ADDENDUM NO. 5

**LIBERTY INTERMEDIATE SCHOOL ADDITIONS
AND RENOVATIONS
Chesterton, IN 46304**

ADDENDUM FIVE

Addendum Five (AD.05) to the drawings and specifications prepared by Gibraltar Design for **Liberty Intermediate School Additions and Renovations** for Duneland School Corporation, Chesterton, Indiana.

A-803

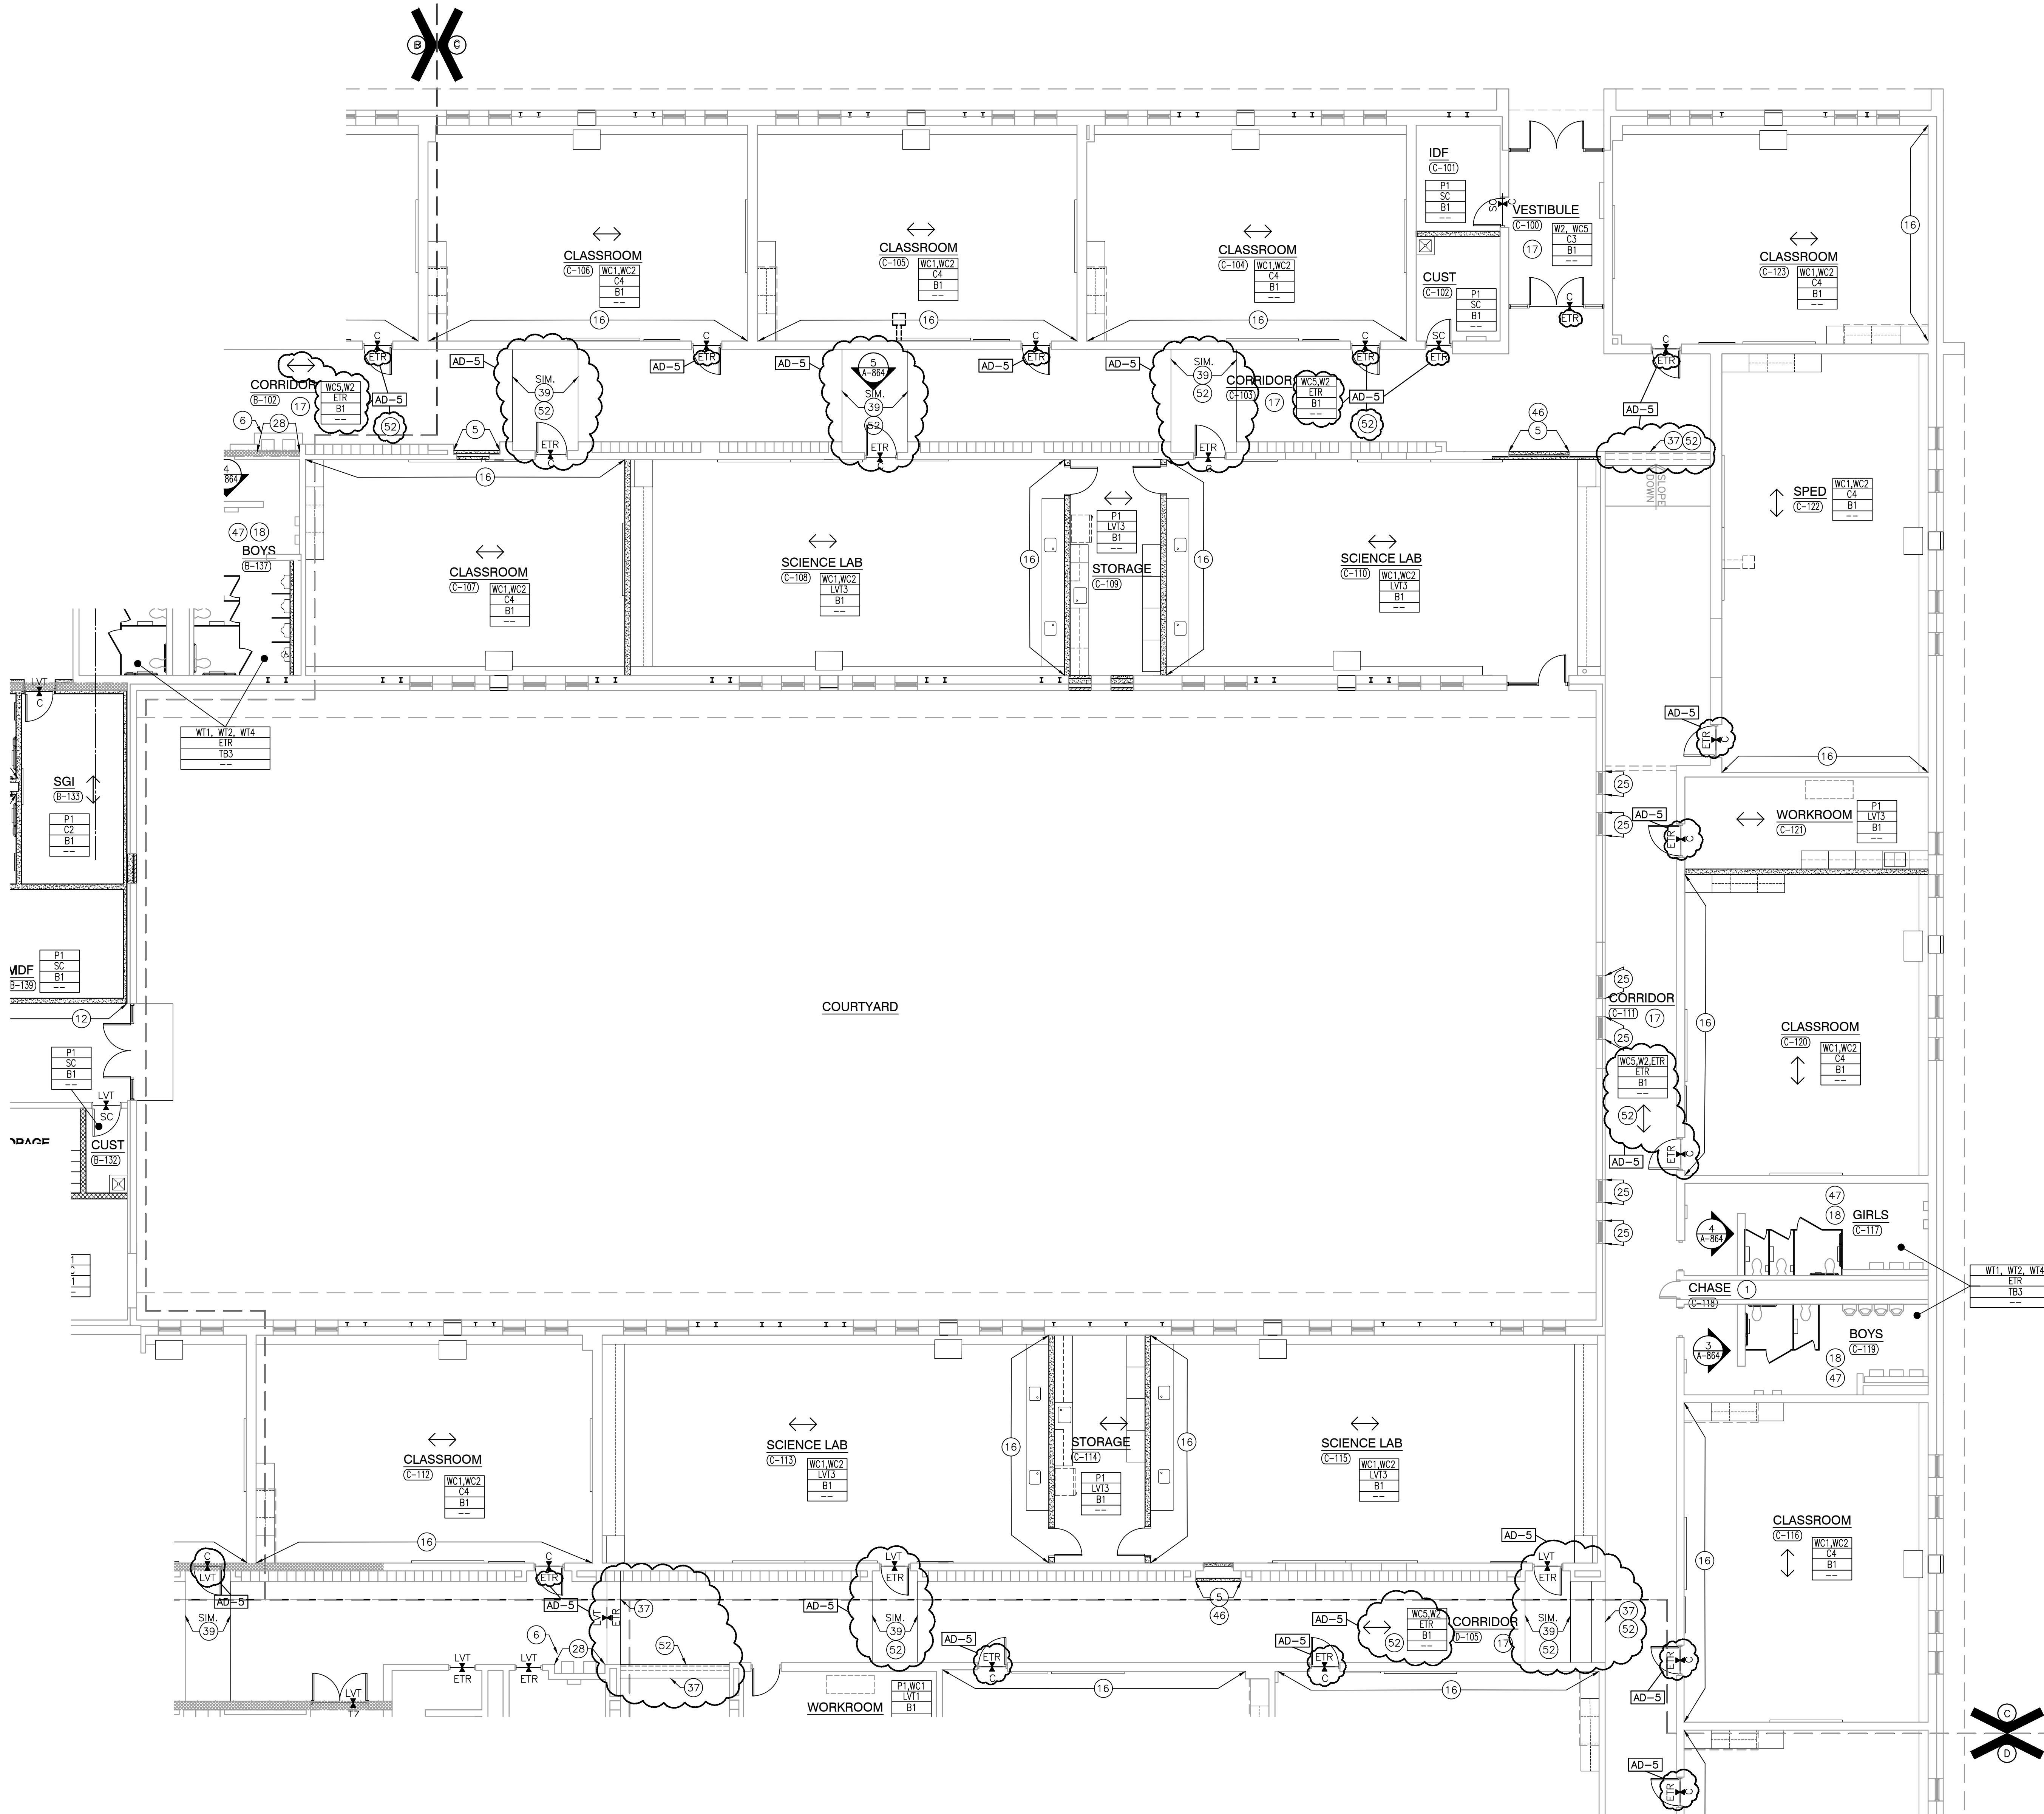
8. **Sheets A-802, A-803, A-804**
 - A. Refer to Three (3) revised full-size drawings included in this Addendum, for revisions.
9. **Sheet MP104**
 - A. Refer to revised full-size drawing, included in this Addendum, for the following revisions.

© GIBALTAR DESIGN SHEET
E-002

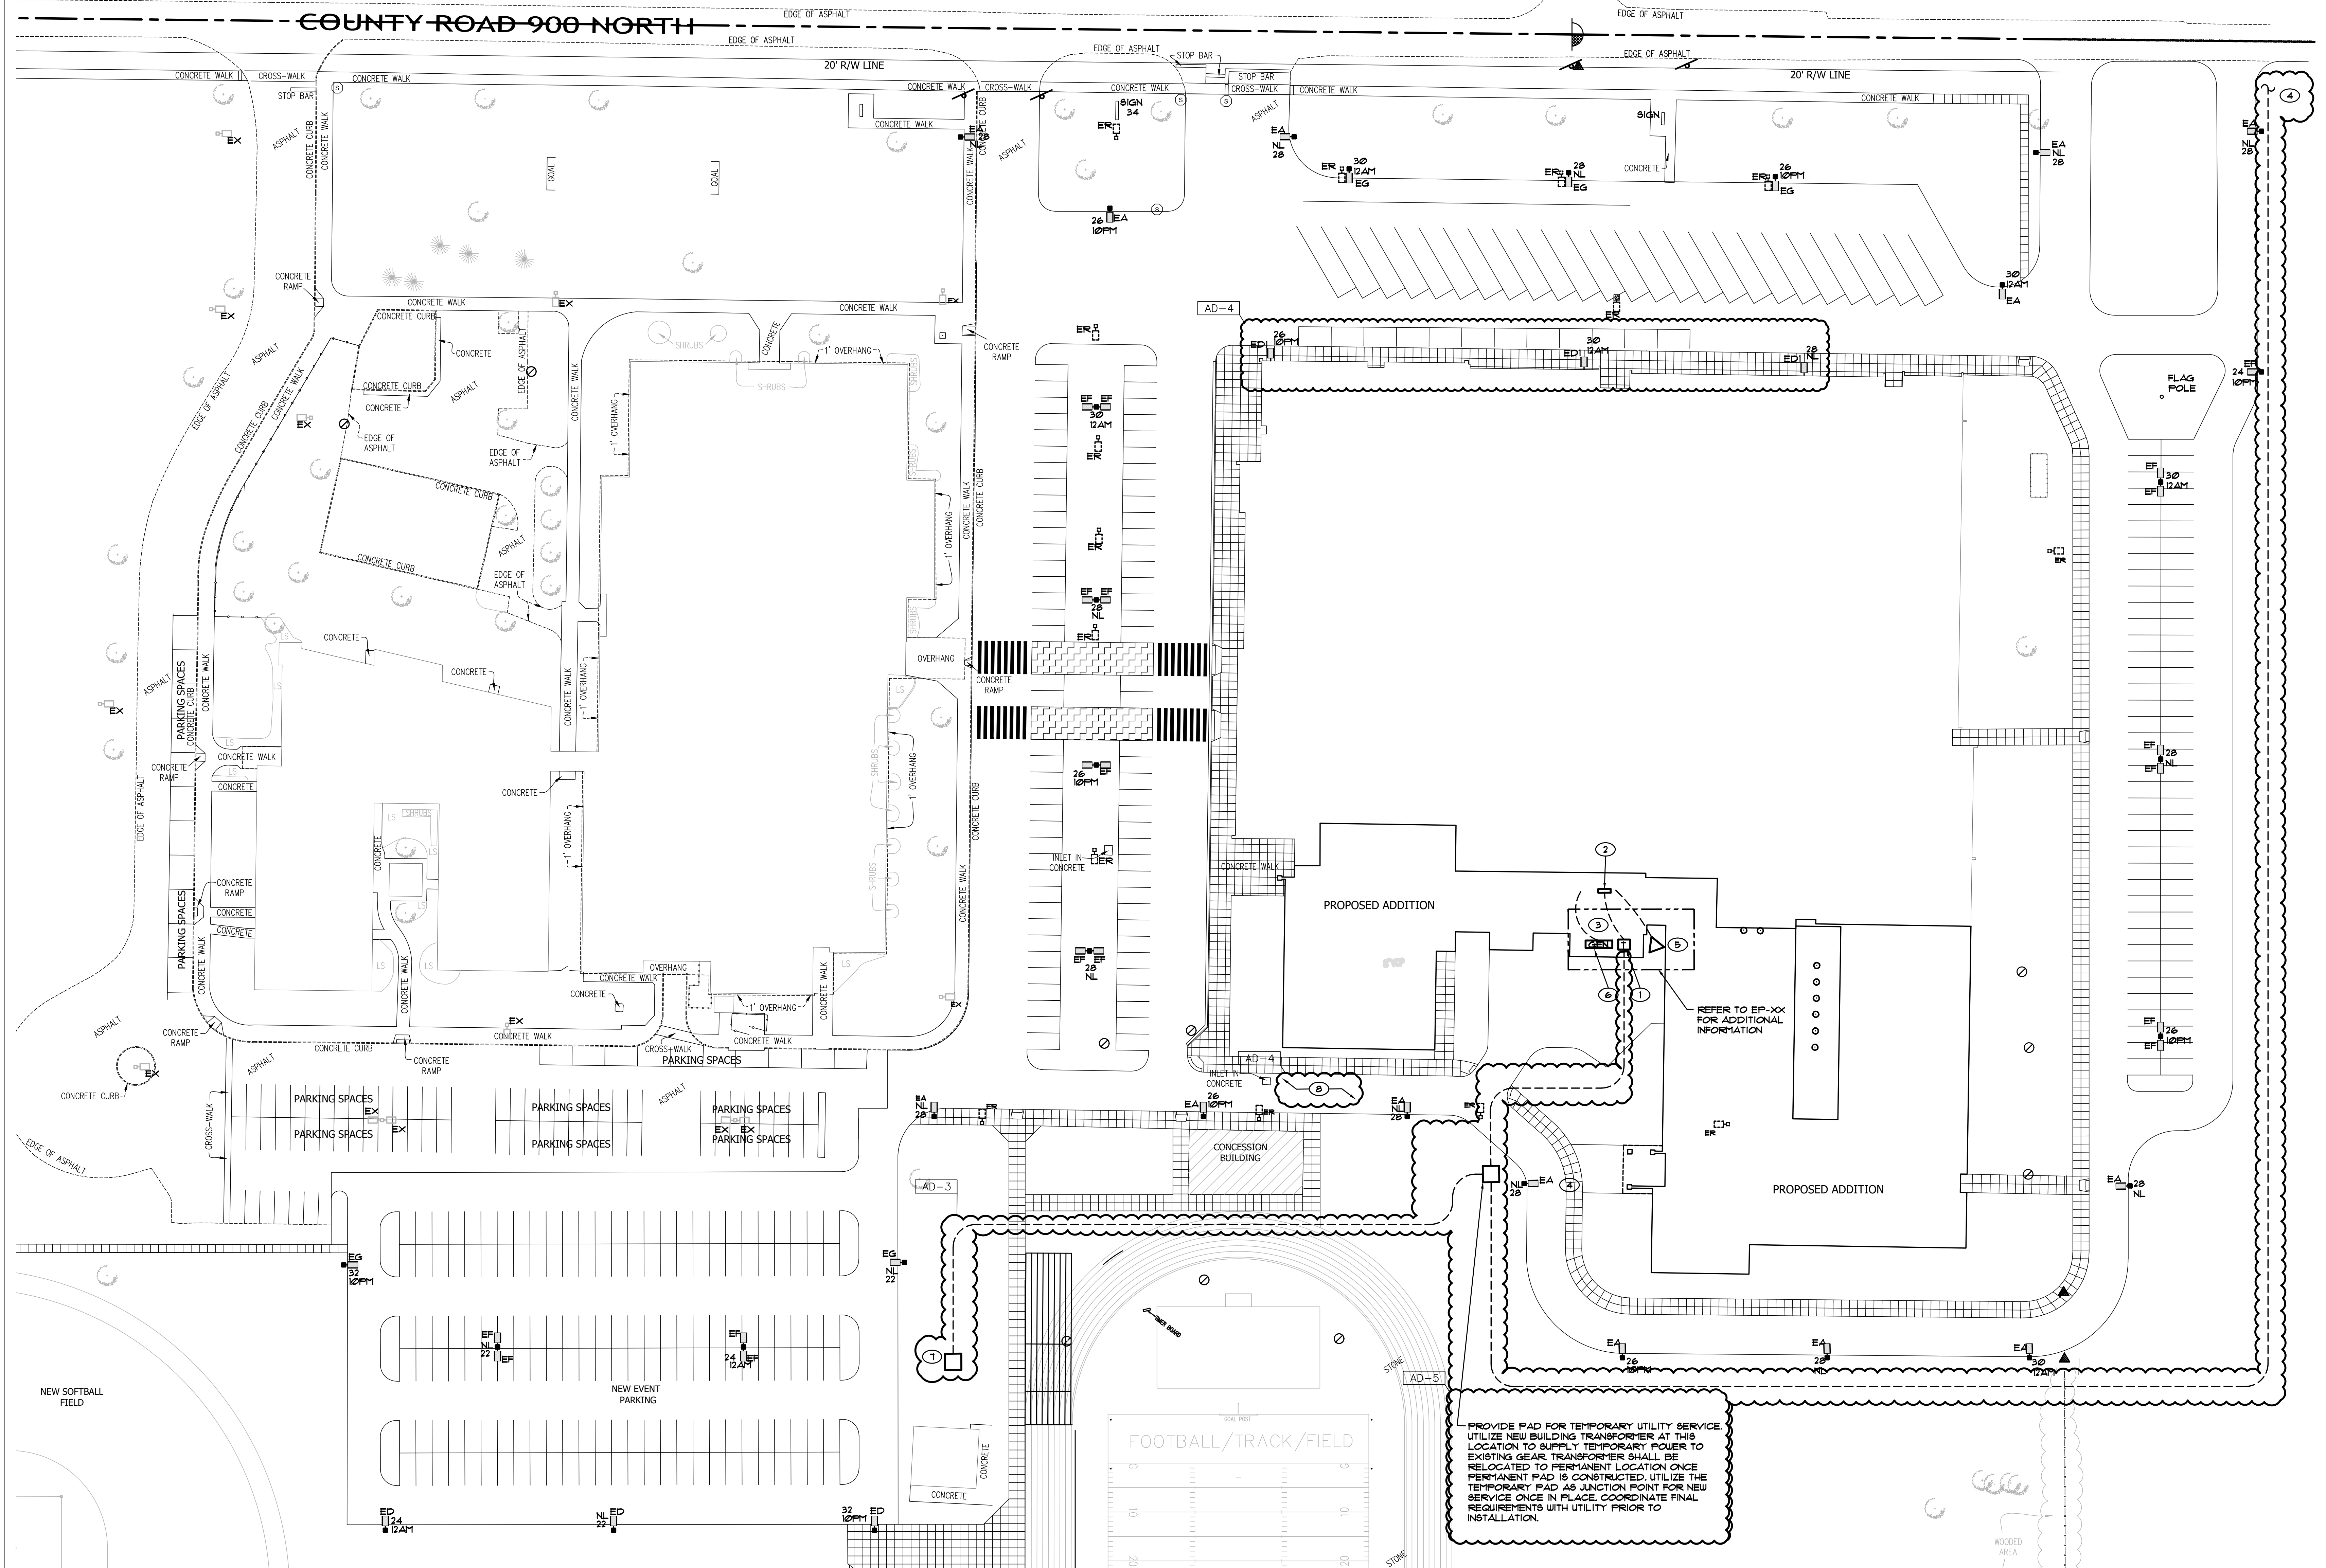
17. Sheet E-002

- A. Refer to revised full-size drawing, included in this Addendum, for the following revisions.

1. Clarify note regarding temporary transformer pad.
